21 February 2014

**Lewisham VPA Review - Meriton & Marrickville Council
78-90 Old Canterbury Road, Lewisham**

Figure 2: Existing Trunk Drainage System

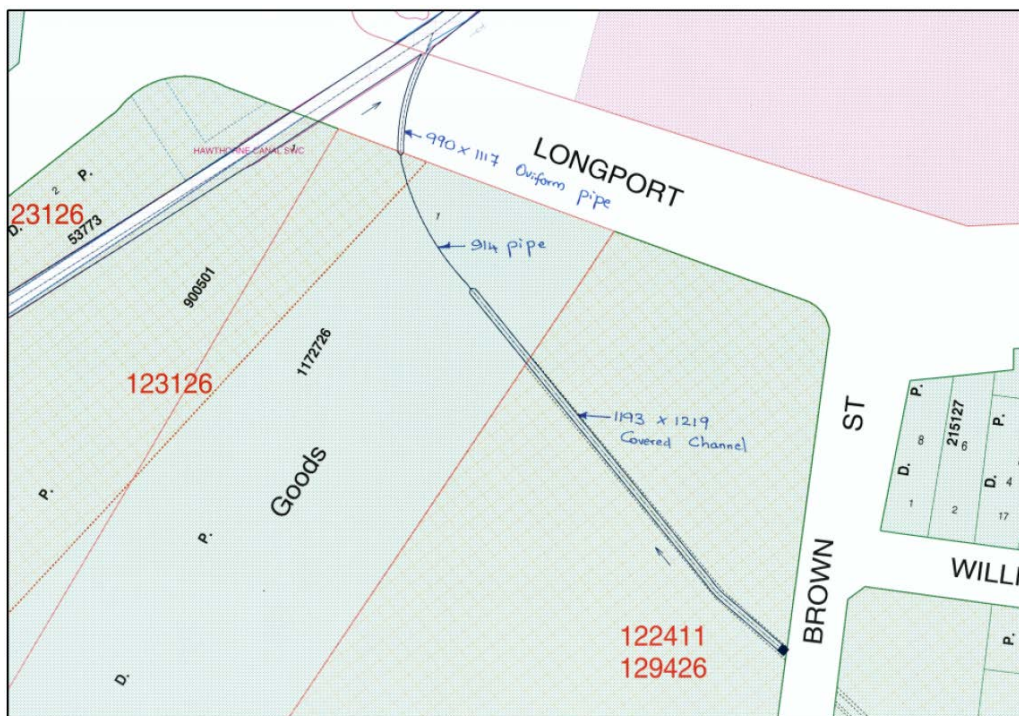
The existing trunk drainage system in the area of the site consists of a 1,193 x 1,219 mm covered channel and a 900 mm pipe, as shown in Figure 2 (reproduced from Annexure 8 of Meriton's Modification Application).

No hydraulic calculations were provided to support the claim that 'replacement' existing scheme would be equivalent to the actual existing system.

Figure 3: Flood Modelling Reference Points

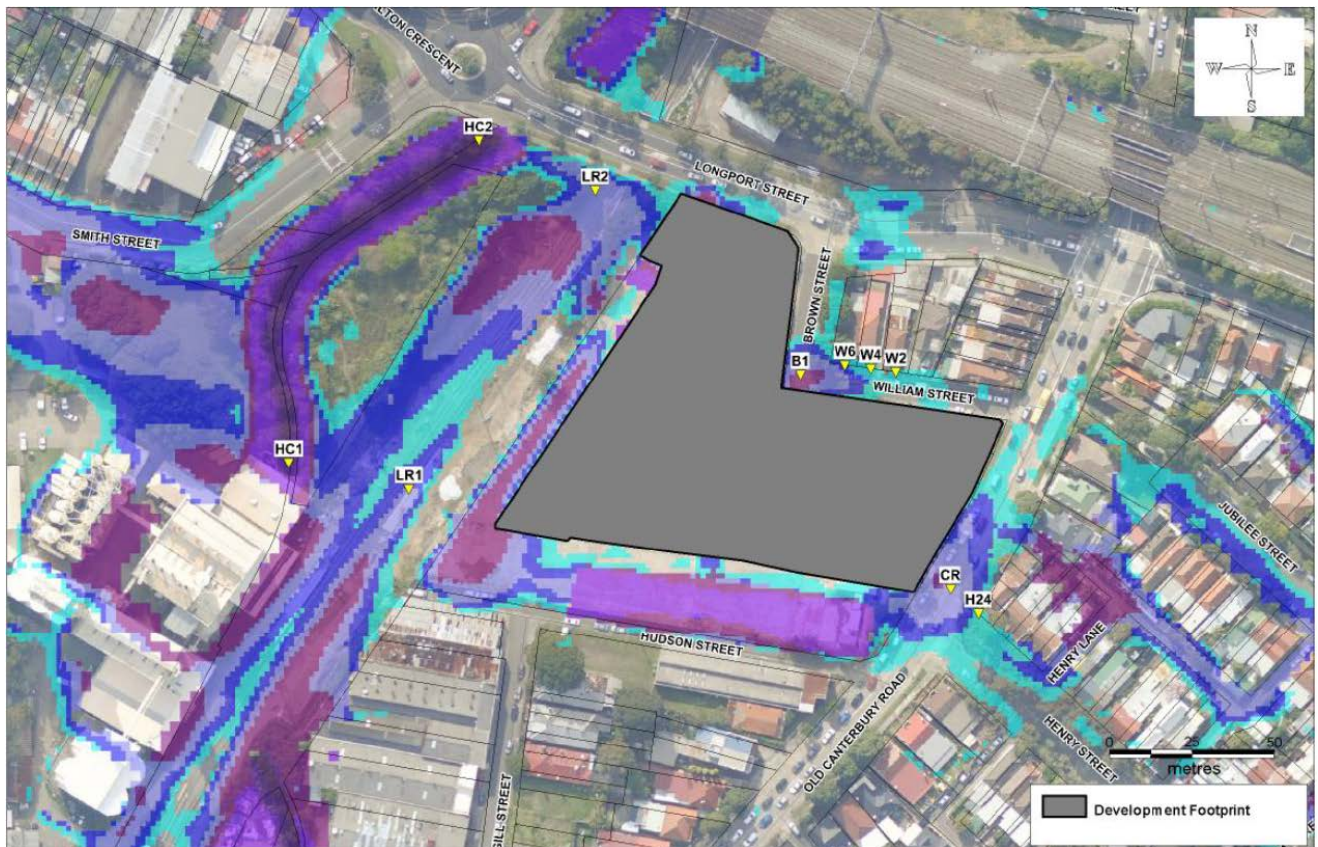
- HC1 Hawthorne Canal opposite Hudson Street (west of the site)
- HC2 Hawthorne Canal upstream of Longport Street (west of the site)
- LR1 Lewisham Light Rail Station (light rail corridor west of the site)
- LR2 Light Rail Upstream of Longport Street (light rail corridor west of the site)
- B1 Intersection of Brown and William Street north of the site
- W6 6 William Street (adjoining property north of the site)
- W4 4 William Street (adjoining property north of the site)
- W2 2 William Street (adjoining property north of the site)
- CR Centreline of Old Canterbury Road (upstream to the east of the site)
- H24 South-west corner of 24 Henry Street (adjoining property, upstream to the east of the site).

The locations of these reference points are shown in Figure 3 below, reproduced from the Cardno Discussion Paper.
